CPSES-200100928  
Log # TXX-01071  
File # 236  
May 4, 2001

**SUBJECT: COMANCHE PEAK STEAM ELECTRIC STATION (CPSES)  
DOCKET NOS. 50-445  
REQUEST FOR ADDITIONAL INFORMATION REGARDING  
STEAM GENERATOR TUBE REPAIR USING LASER WELDED  
SLEEVES**

## SLEEVE Code Summary Report

Figure 1

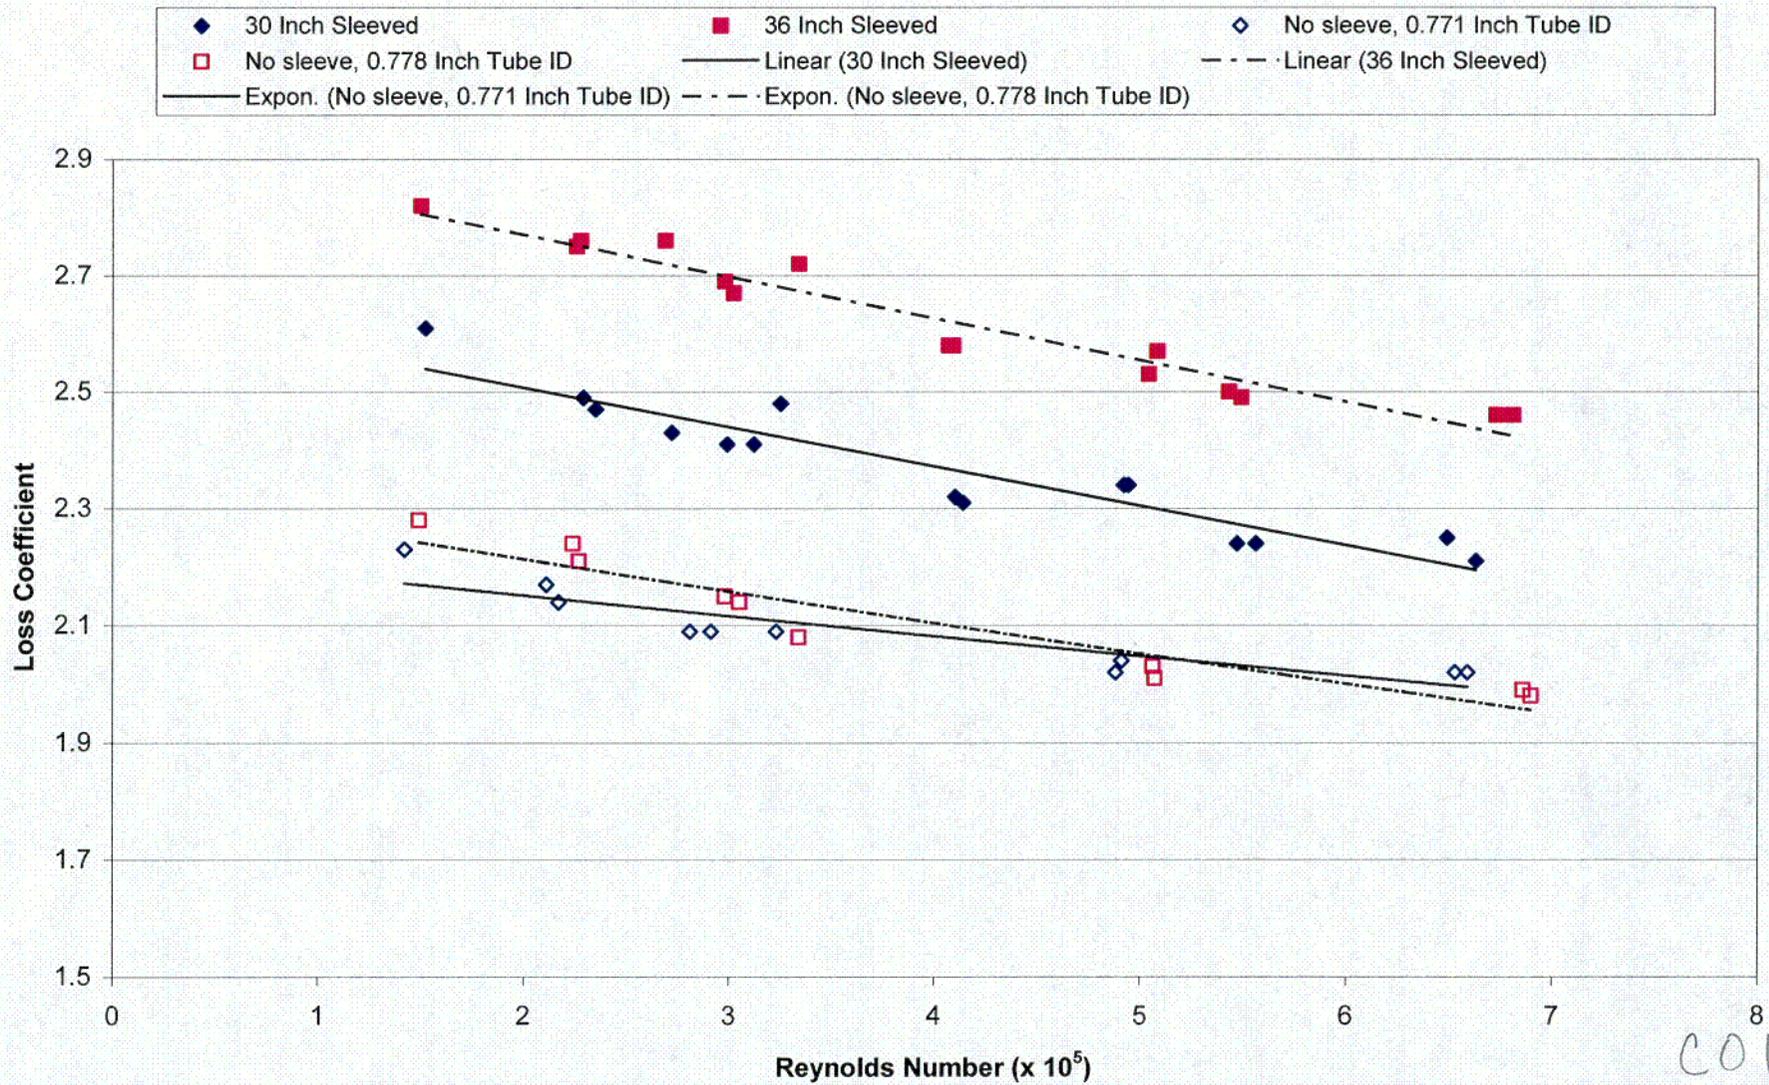
The test procedure involved testing first the unsleeved tube configuration. Pressure taps were provided at the inlet to the tube, and at a location downstream of the eventually installed sleeve. Pressure measurements were performed for varying flow rates (33 to 67 gpm) and fluid temperatures (78 to 155°F). HEJ sleeves were then installed. The flow rates and temperatures used in the unsleeved case were then repeated for the sleeved case. Pressure/flow measurements were repeated for each case. The pressure data were then used to compute the loss coefficients and Reynolds Number for each case. The resultant loss coefficients and Reynolds Numbers were then input into the SLEEVE code to determine the hydraulic equivalencies for the unsleeved and sleeved cases. As sleeves can be installed in both the hot leg and cold leg in the same tube, the test configuration was such that a sleeve was installed in both ends of the tube. A prototypic Reynolds Number for operating SGs is approximately  $9 \times 10^5$ . The range of test parameters produced Reynolds Numbers ranging from  $1 \times 10^5$  to  $7 \times 10^5$ . These values were selected to examine the effects of Reynolds Number upon hydraulic equivalency as the RCS temperature and flow rates change during the power escalation cycle. Figure 1

presents a summary of the calculated loss coefficients for each case, unsleeved and sleeved, for varying Reynolds Numbers. As seen from this figure, the unsleeved case yields loss coefficients approximately equal for the 30" and 36" test setups. For these two cases, the tube ID's varied by a few mils. As would be expected, the 30" sleeved case has a lower loss coefficient than the 36" sleeved case.

Once the loss coefficients for the sleeved tube test case were determined, the hydraulic equivalency was determined for the test conditions. The hydraulic equivalency was then determined using the standard input assumptions applied to the SLEEVE code. The result shows that the standard input assumptions and calculational methodology of the SLEEVE code is quite conservative compared to the test data for prototypically installed sleeves.

For the 30" hot leg sleeve, the hydraulic equivalency determined from the test data was found to be on average 3.38 times greater than the hydraulic equivalency calculated using the SLEEVE code. For the 36" hot leg sleeve, the hydraulic equivalency was found to be on average 2.35 times greater than the hydraulic equivalency calculated using the SLEEVE code. The test data suggests that as the Reynolds Number increased, the ratio of hydraulic equivalency for test to calculated conditions indicates a slightly increasing ratio. Thus for the prototypic Reynolds Number conditions, the actual hydraulic equivalency should be larger for the actual installed condition. The variance between test and calculated hydraulic equivalencies may be due to actual installed conditions of the 30" and 36" sleeves and individual tube conditions.
